# Access Compliance Report

## Public Rights-of-Way

### (Curb Ramps)

Intersection ID: 43358	Main Street: PROSPERITY COMMONS DR	Cross Street: ROCKY FORD CLUB RD	Location: NW
ADA ID: 01A62C7CAFE6	Ramp Type: Perp	Initial Pass/Fail: Pass	Overall Compliance: No
Severity Score: 1.25			
Codes/Mitigation Info/Possible Solution		Field Measurements/Component Compliance

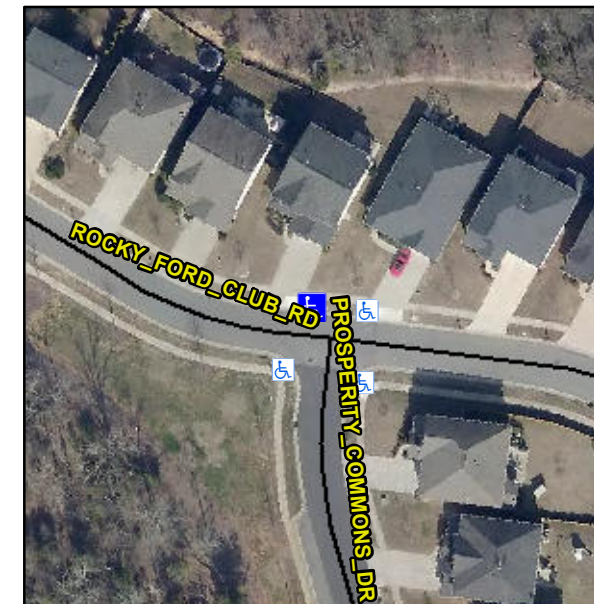
**Not Found, R304.5.1**

Compliance	Description	Data	Compliance	Description	Data
N/A	Ramp Length (in)	70.0	Yes	Ramp Slope (%)	6.4
No	Ramp Width (in)	47.5	Yes	Ramp XSlope (%)	1.4
N/A	Flare Type LT	Sloped	N/A	Flare Type RT	N/A
N/A	Flare Slope LT (%)	8.0	Yes	Flare Slope RT (%)	1.2
N/A	Flare Traversable LT?	Yes	N/A	Flare Traversable RT?	Yes
Yes	Landing Length (in)	48.0	Yes	DWS Provided?	Yes
Yes	Landing Width (in)	48.0	Yes	DWS Contrast?	Yes
Yes	Landing Slope (%)	1.9	Yes	DWS Length (in)	24.0
Yes	Landing X Slope (%)	2.0	Yes	DWS Full Width?	Yes
N/A	Landing Curb? (Y/N)	No	Yes	DWS Offset (in)	1.5
N/A	Shared Landing?	Yes			
Yes	Gutter Ponding?	No	Yes	Gutter Slope (%)	2.7
Yes	Gutter Lip Ht (in)	0.0	Yes	Gutter X Slope (%)	1.1
N/A	Painted X Walk1?	No	N/A	Painted X Walk2?	N/A
	X Walk 1 Direction	To SW		X Walk 2 Direction	N/A
N/A	X Walk 1 Width (in)	N/A	N/A	X Walk 2 Width (in)	N/A
	X Walk 1 Slope (%)	1.1		X Walk 2 Slope (%)	N/A
	X Walk 1 X Slope (%)	2.7		X Walk 2 X Slope (%)	N/A

**Remove & Replace Entire Ramp.**
